FISH AND WILDLIFE SERVICE

April 3, 2026

I was contacted in an email from you on March 9, 2026 regarding the Low Hydro Impact Institute's (LIHI) application by the Chicopee Falls Project (P-6222) owners, on the Chicopee River, Massachusetts. I convened an ad hoc meeting of the Technical Committee of the Connecticut River Migratory Fish Restoration Cooperative where we discussed this email request and the broader LIHI program. My responses, on behalf of the U.S. Fish and Wildlife Service (USFWS), are informed by the broader group discussion of basin resource agency members and consensus, that are provided here.

Figure 1. The range of American Eel in the Chicopee River Basin (MA), based on electrofishing samples from 1984 to 2024, from MADFW (USFWS draft GIS).

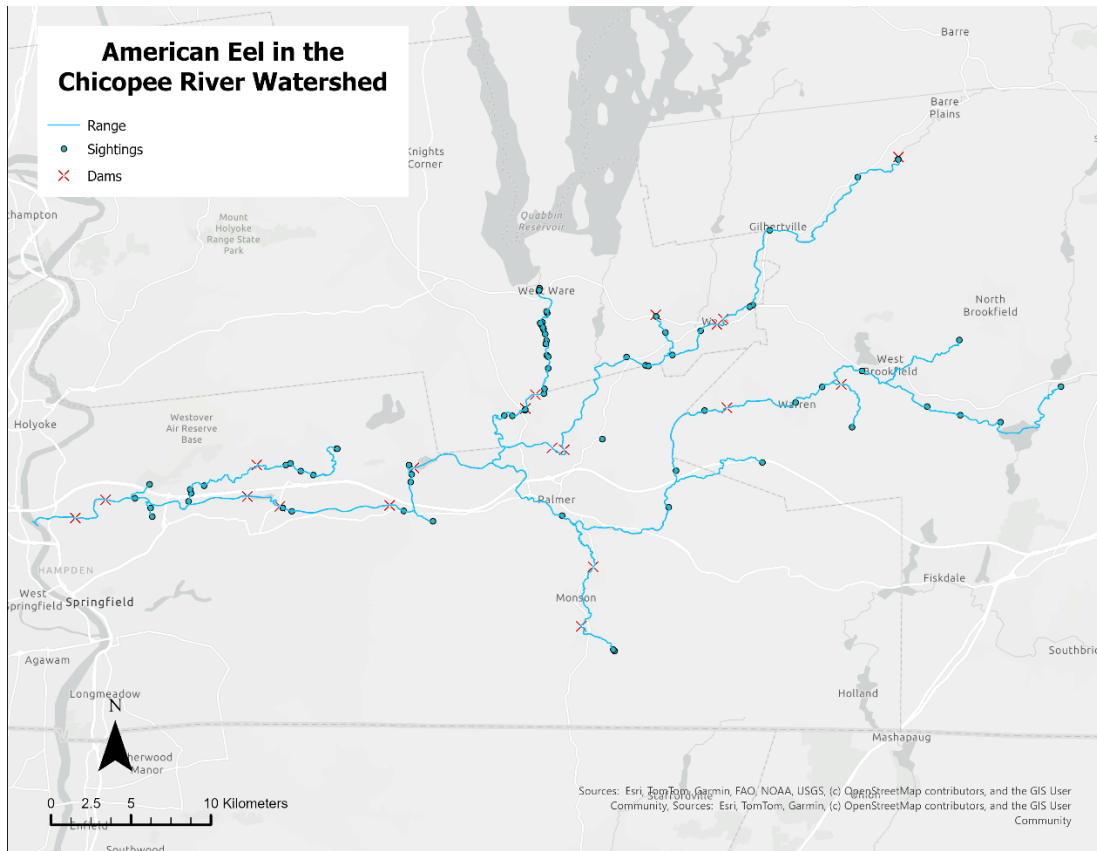
1) *What is the status of American Eel in the river? Are you aware of eel populations there? There have been prior anecdotal reports. If so, can you quantify the populations?*

Response – American Eel are documented throughout the Chicopee River basin in areas upstream of the Chicopee Falls Project. The Connecticut River Atlantic Salmon (CRASC) Connecticut River American Eel Management Plan (2023), reports data on these occurrences from the Massachusetts Division of Fisheries and Wildlife (MADFW). A more recent data gathering effort has been applied to a Geographic Information System project, by my office, that utilizes electrofishing detections of American Eel (Figure 1). It should be noted that the absence of sample evidence from electrofishing should not be taken as proof of absence of eel. This is due to the fact detections are based on daytime electrofishing and eel are known to be nocturnal and seek dense cover to shelter in during daytime. The survey data cannot be used to quantify the population based on the study design(s) of those efforts. However, the data do support a fairly extensive range distribution in spite of there being no dedicated upstream eel passage on dams in this system, currently.
